Concerns modification to Unit No. 2..  
regarding control of certain ECCS related  
valves from the control room with the  
objective of satisfying the single failure  
criteria & to eliminate the present  
requirement for operator action....ACKNOWLEDGED  
DO NOT REMOVE

April 25, 1977

H. B. ROBINSON STEAM ELECTRIC PLANT UNIT NO. 2  
LICENSE NO. DPR-23  
DOCKET NO. 50-261  
LOCKOUT OF CRITICAL ECCS VALVES

FIGURE 2

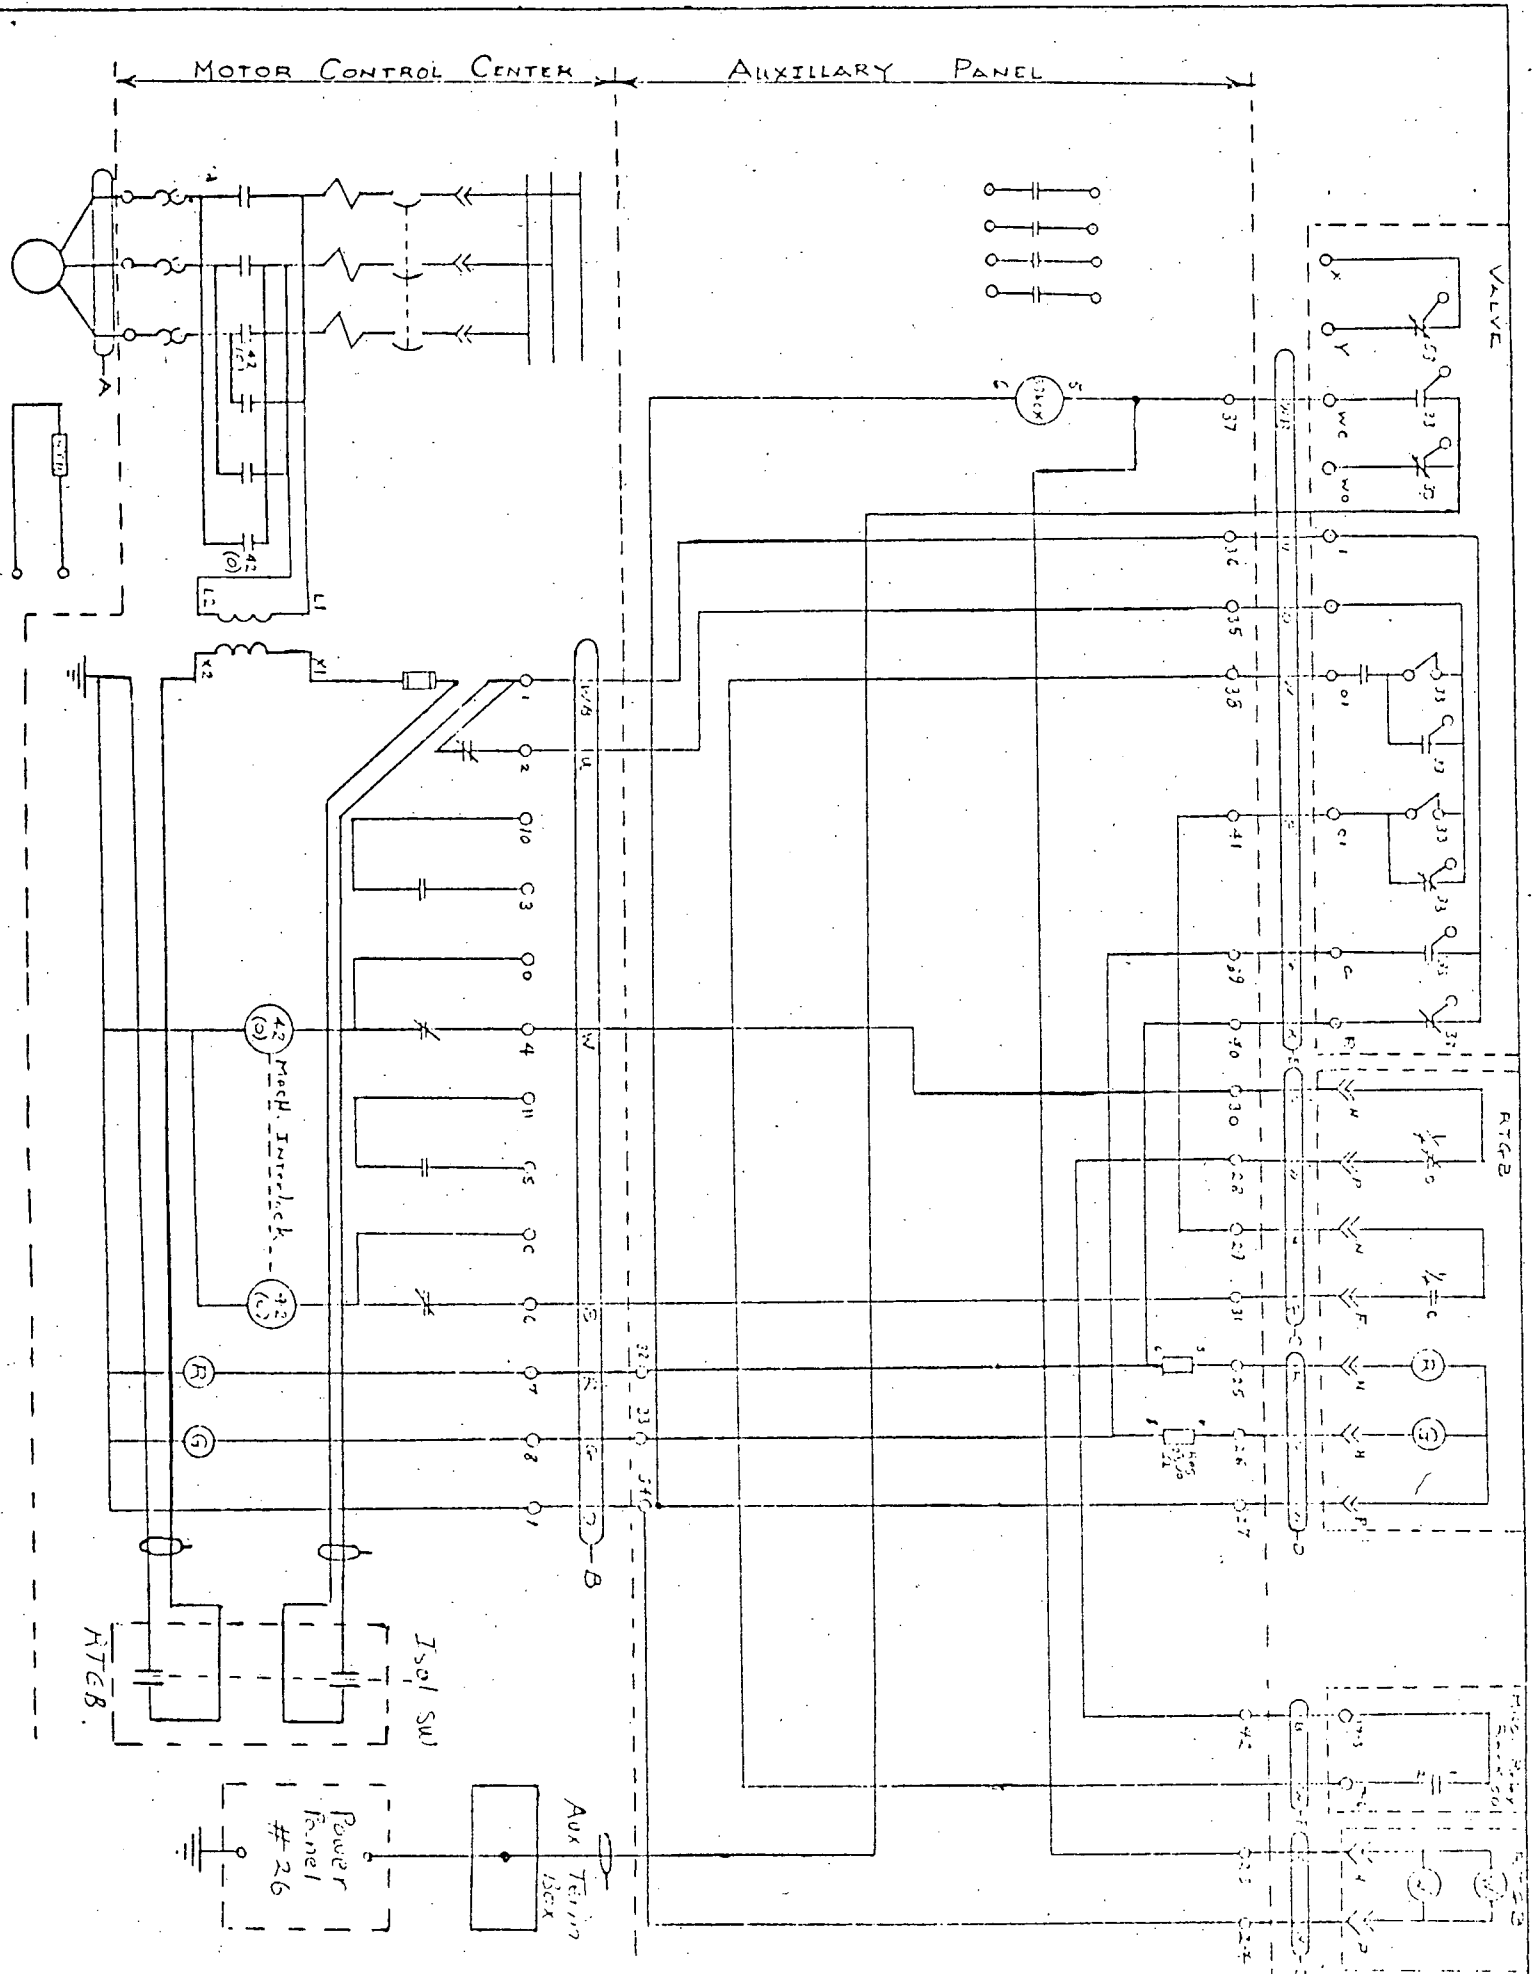
This modification will use one isolation switch per valve, mounted in the rear of the Reactor Turbine Generator Board (RTGB) and readily accessible to the plant control operator inside the control room. The valve isolation switch will open contacts in both the "hot" side and ground side of the control transformer of the valve control circuit.

Flame retardant cables from the isolation switch to the separate contacts in the control circuitry will be physically separated and run in individual conduits along different routes. In addition, a separate power supply will be provided for the Vital Valve Status Panel indication lights. These valve position

indicators are presently energized from the same power supply as the valve control circuits. The separate power supply will be routed to a spare contact on the valve position switch. Ratings and physical positions of the contacts eliminate the probability of an over current condition on the normal indication circuit affecting the alternate indication circuit.

The attached Figure 1 shows a typical control wiring diagram for a valve motor operator as presently configured. Figure 2 shows the proposed addition of the valve isolation switch, the separate valve position indication power supply, and the associated wiring.
